Docket No.: 71-9187 & TAC No.s L24229 & L24230

Subject: RAI Response for Model 865 Type B Container

Enclosure A – Drawing R86590 Rev J with Table of Drawing changes

TITLE MODEL 865 TYPE B PROJECTOR
 DESCRIPTIVE ASSEMBLY

SIZE DWG. NO. R86590
 SCALE: NONE SHEET 2 OF 8

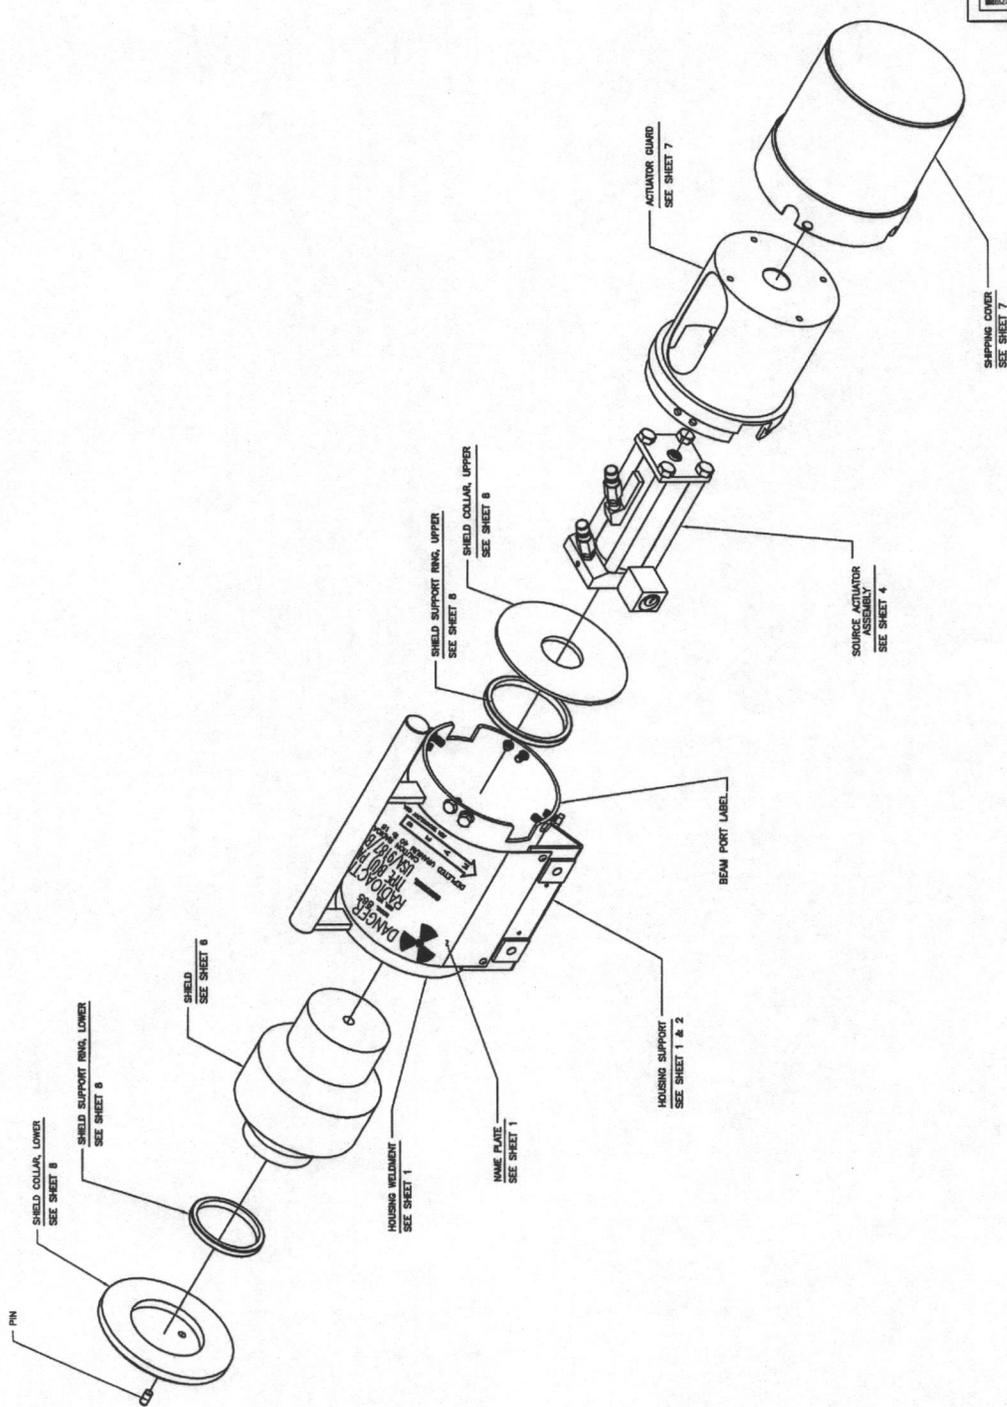
1-2 The term "or equivalent" has been removed from drawing R86590 sheet 1, note 2 in Revision J (see Appendix A).

Sheet 1	Note 2 is revised to remove the words "or equivalent requirements" in reference to inspectors qualified to ASNT SNT-TC-1A.	No	No change to package construction or design. Detail added for completeness and clarity only.	None. Not applicable.

SIZE DWG. NO. R86590
 B SCALE: NONE SHEET 3 OF 8
 REV J

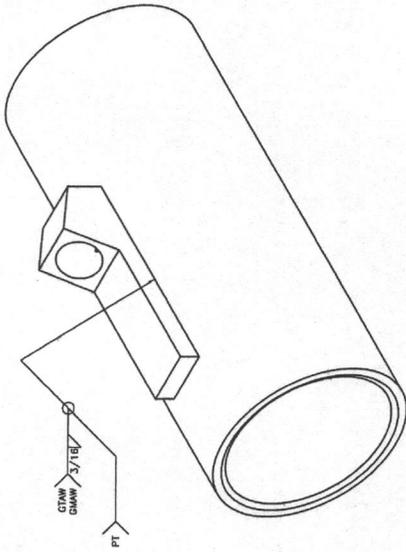
Sheet 3	The part name is corrected from "Shield Collar Ring, Upper" to read "Shield Support Ring, Upper".	No	No change to package construction or design. Change made for accuracy.	None. Not applicable.

SHEET 8 OF 8

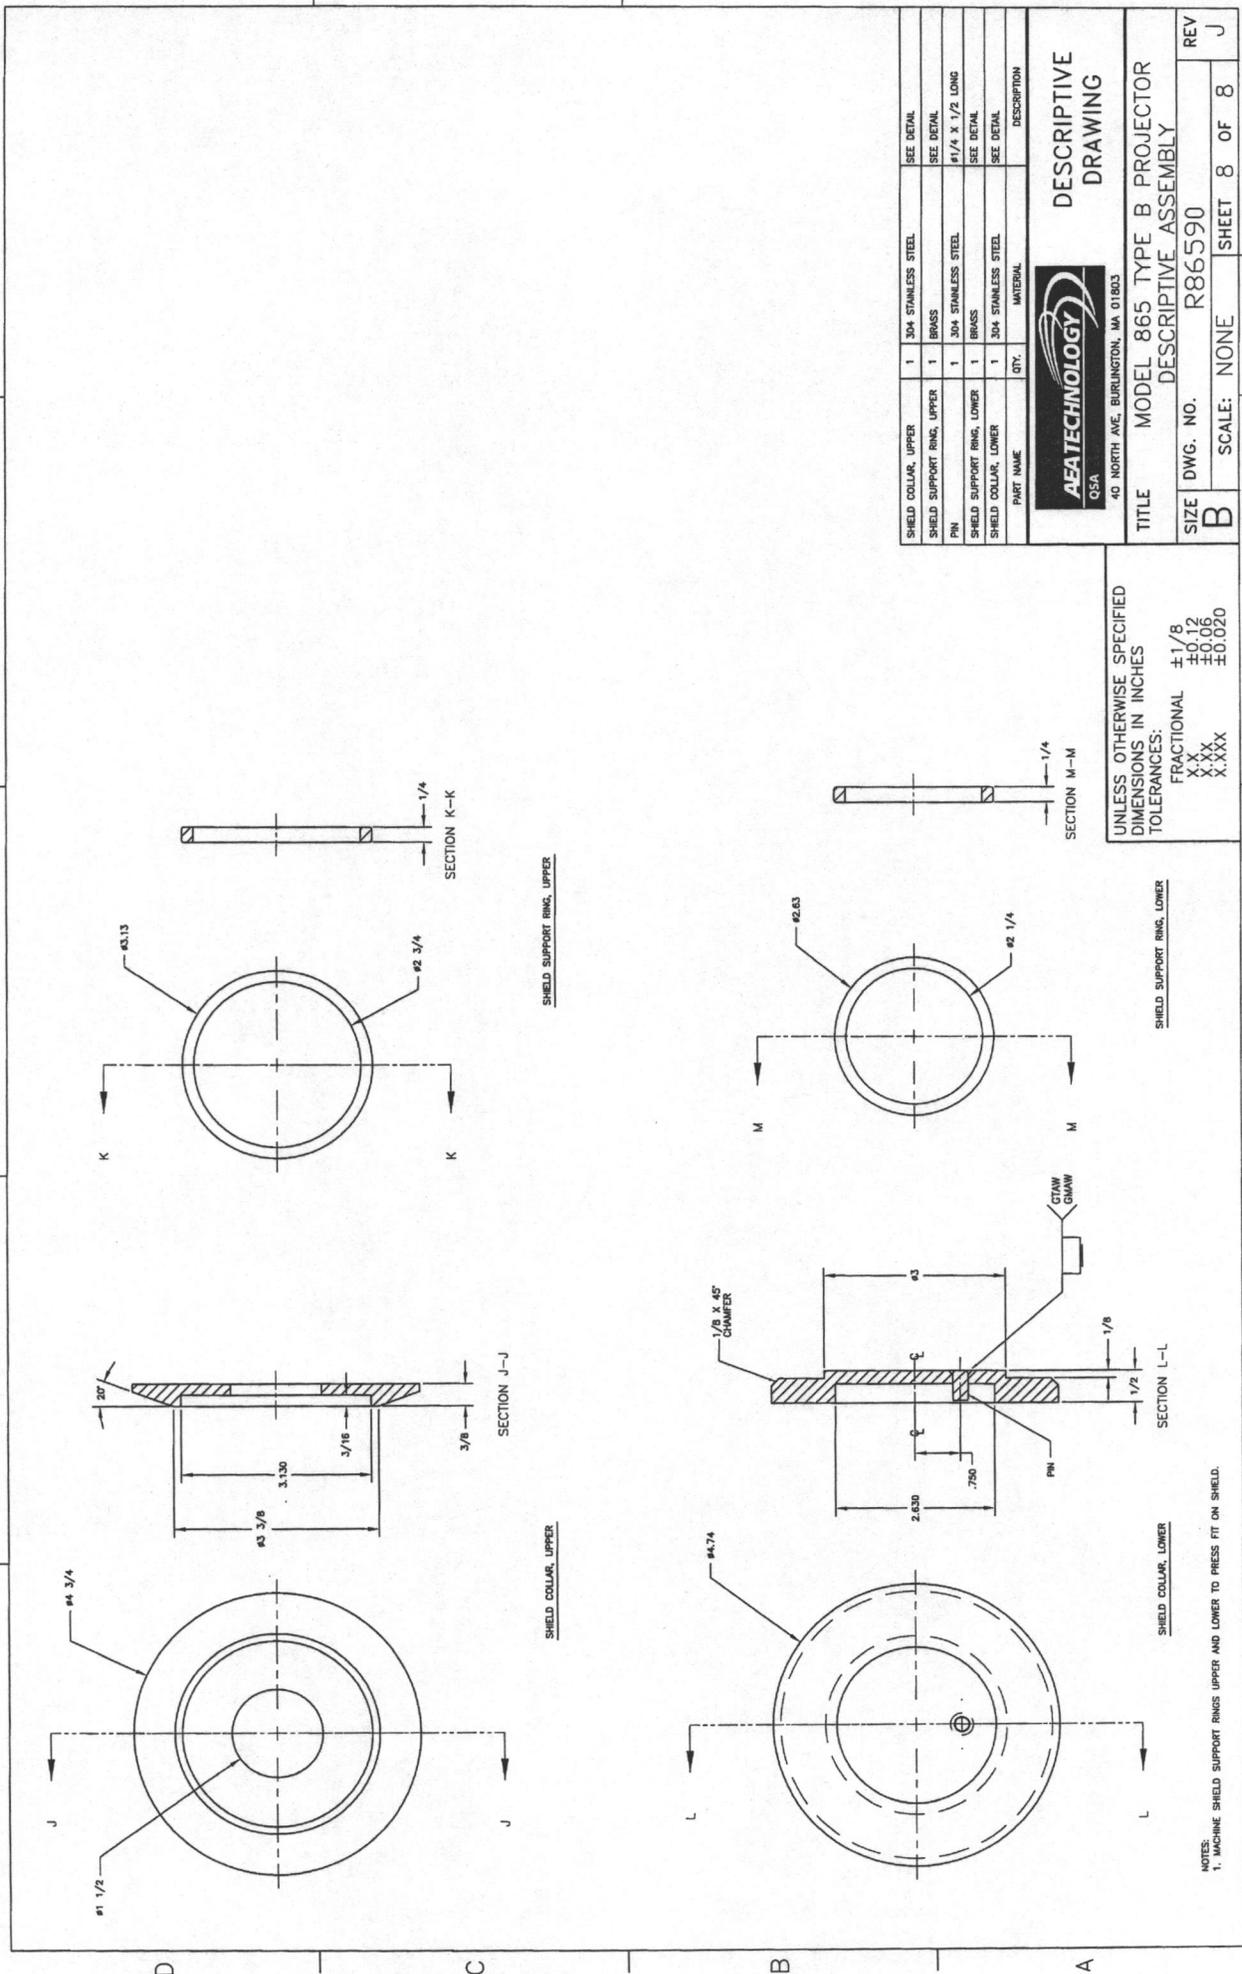
1-3 As discussed during our site visit on 3 December 2008, the best method for identifying shielding porosity is an adequate radiation survey. Specifying a minimum shield weight is not a reliable or adequate means for identification of a defective shield due to porosity.

DEPLETED URANIUM SHIELD SHIELD WEIGHT: 42 lbs. MAXIMUM
